Blount County Planning Department

MEMORANDUM

SUBJECT: Staff reports on agenda items for the Thursday July 27th, 2006 regular meeting. 5:30 Hearings and Site Plans

1. Determination of subdivision capability at end of Charles Young Road for Barbara Law property.

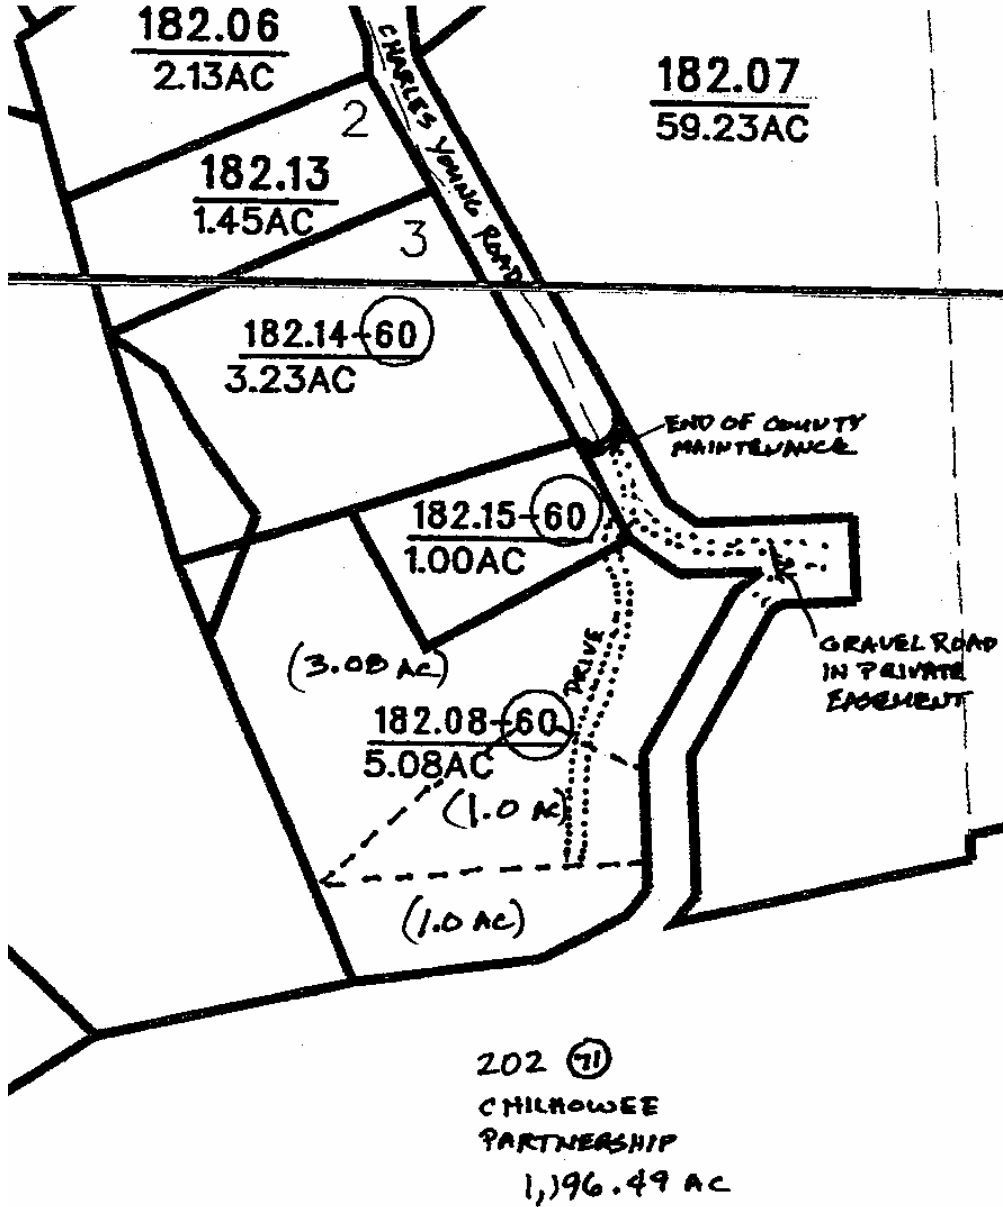
See tax map on next page for reference. Barbara Law owns a one acre tract at the cul-de-sac end of pavement and County maintenance of Charles Young Road (parcel 182.15 - one lot subdivision approved November 2002). Ms Law also owns a 5.08 acre tract with frontage on a private easement that continues on beyond the end of public right-of-way of Charles Young Road (parcel 182.08). The easement is part of a large 1,196 acre tract (parcel 202 in R-2 zone) owned by Chilhowee Partnership. Staff has not determined the rights of Ms Law on the easement. Adjoining parcel 182.07 also utilizes the easement, but also has frontage on the County maintained public road.

Ms Law wishes to divide two additional one acre tracts with existing houses as shown by dotted lines on the tax map (parcel 182.08 is appropriately zoned R-1), resulting also in a third parcel with remaining land of 3.08 acres that would also need to be platted.. There is an existing gravel drive across parcel 182.08 to the two houses, and Ms Law intends to use the drive as common driveway access to the three proposed lots. Ms Law contends that the common drive will come directly off of the County maintained public road - Charles Young Road.

2. Determination of subdivision capability off of Ownby Road straddling R-2 and R-1 zones for Wright and Johnson (Ownby) properties.

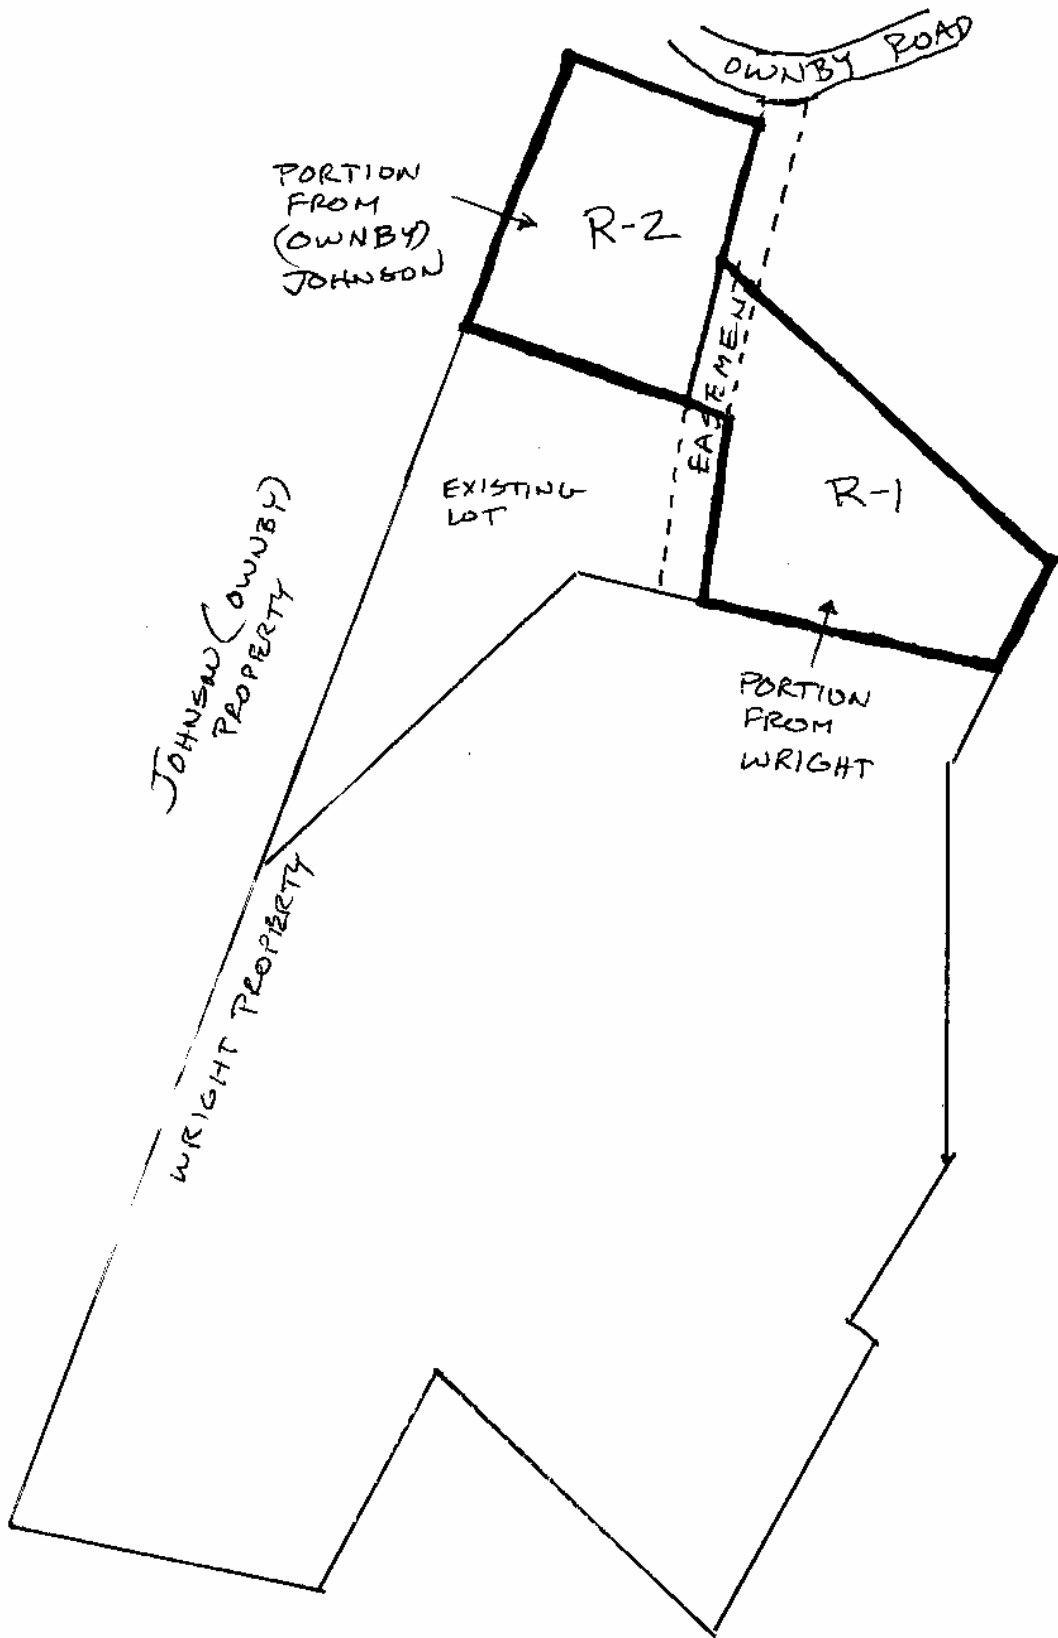
See concept for division on next page for reference. Gary and Janna Lamb wish to purchase approximately one acre in two parts from two neighboring properties, about one-half acre from Johnson (Ownby) and one-half acre from Wright. Johnson (Ownby) and Wright have agreed in writing to sell the separate parts of the proposed lot to the Lambs to create a single lot. The property will be accessed via an existing easement off of Ownby Road. The two portions of the lot straddle the easement of access, and contain substantial level ground for both building and septic. The proposed lot will be on septic and well water.

Staff requests determination of subdivision capability for the proposed lot given the finding that the lot size requirement will not technically be met in the separate zones. The main question is: Does the combined lot area suffice for division as intended, granted that the majority of lot requirement will be met in the R-1 zone.
